Review of first years deliverables

BEACON EARB – Expert Advisory Review Board

Remarks on D1.1 State-of-the-Art Report on ...

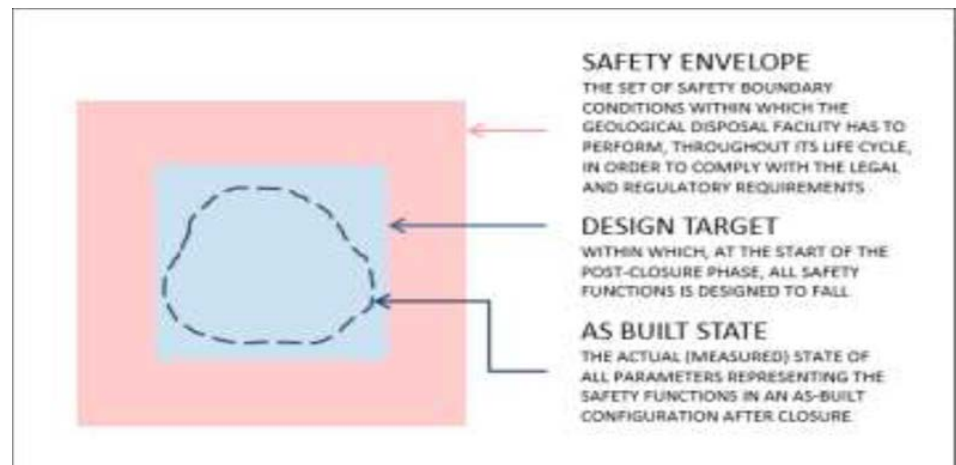
- **Performance measures**

- Are identified differently by the different partners. Some are giving preferred values others are not.

Preferred value is not really helpful in terms of performance assessment

we have to know how far we can deviate (e.g. in case of inhomogeneities) from this preferred value to stay in the safety envelope.

- It would be preferable to give the performance measures in terms of safety envelope and design target as proposed in GEOSAF II: <https://www-ns.iaea.org/downloads/rw/projects/geosaf/geosaf-tecdoc-draft.pdf>
